NASCAR Technical Bulletin

NKNPS13 – 7 – 12/4/13

Effective January 1, 2014 – The following are amendments to the 2013 NASCAR K & N Pro Series Rule Book and will be incorporated into the 2014 NASCAR Rule Book:

SECTION 20C NASCAR K & N PRO SERIES EAST / WEST

DIAGRAM 13 - SEAT PADDING

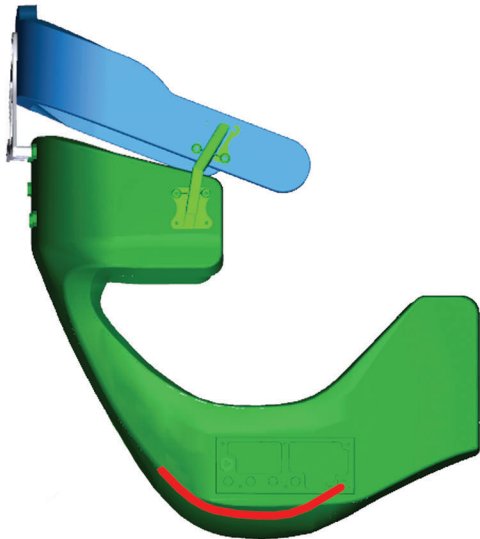
B. Each car must be equipped with an SFI 39.1 approved seat and headrest/head surround assembly displaying valid SFI 39.1 labels and be acceptable to NASCAR. Custom-manufactured aluminum seats constructed from solid aluminum sheet material from the seat bottom to above the driver's shoulders, acceptable to NASCAR, will be permitted. NASCAR-approved composite material seats will be permitted. Composite material seats and/or seats which incorporate lap and/or shoulder belt anchorages are subject to additional testing with documentation supplied to NASCAR. Each composite seat must have a unique, identifier that matches records on file with NASCAR. Seats constructed of multiple materials, including composite materials, must be SFI 39.1-approved and must be acceptable to NASCAR. The SFI 39.1-approved seat and headrest/head surround assembly will remain approved for use in competition until their expiration date which is two (2) years after the date of manufacture. Once a seat and headrest/head surround assembly has reached the expiration date, the seat and headrest/head surround assembly must be inspected and recertified by the seat manufacturer. All seat interiors must be lined with inserts and/or padding. It is recommended that a minimum thickness of two (2) inches of SFI 45.2 insert/padding be used. It is recommended that the padding meet the SFI 45.2 specification and display a valid SFI 45.2 label. All non-SFI 45.2 insert/padding materials must be 1/2 inch thick or less. No gaps or non-SFI 45.2 specification approved material(s) may be present between the seat structure and driver's uniform in the area directly under the driver. The area directly under the driver extends from the driver's waist (belt line) forward to the front edge of the sub-strap pass through holes, as well as extends five (5) inches to both the left and right of the driver's centerline. It is recommended, a minimum thickness of 3/4 inches of insert/padding meeting the SFI 45.2 specification be used in this area directly under the driver. The area directly under the driver is shown in Diagram #13, in the rear pages of the Rule Book. A 3/8 inch diameter inspection through-hole must be located on the driver's centerline between the leading edge of the lap belt pass through holes as shown in Diagram #13, in the rear pages of the Rule Book. All seat coverings and/or upholstery should be flame retardant.

C. Seats manufactured or recertified after January 1, 2014, must use the insert/padding meeting the SFI 45.2 specification and display a valid SFI 45.2 label. All non-SFI 45.2 insert/padding materials must be 1/2 inch thick or less. No gaps or non-SFI 45.2 specification approved material(s) may be present between the seat structure and driver's uniform in the area directly under the driver. The area directly under the driver extends from the driver's waist (belt line) forward to the front edge of the sub-strap pass through holes, as well as extends five (5) inches to both the left and right of the driver's centerline. A minimum thickness of 3/4 inches of insert/padding meeting the SFI 45.2 specification must be used in this area directly under the driver. The area directly under the driver is shown in Diagram #13, in the rear pages of the Rule Book. A 3/8 inch diameter inspection through-hole must be located on the driver's centerline between the leading edge of the lap belt pass through holes as shown in Diagram #13, in the rear pages of the Rule Book. All seat coverings and/or upholstery should be flame retardant.
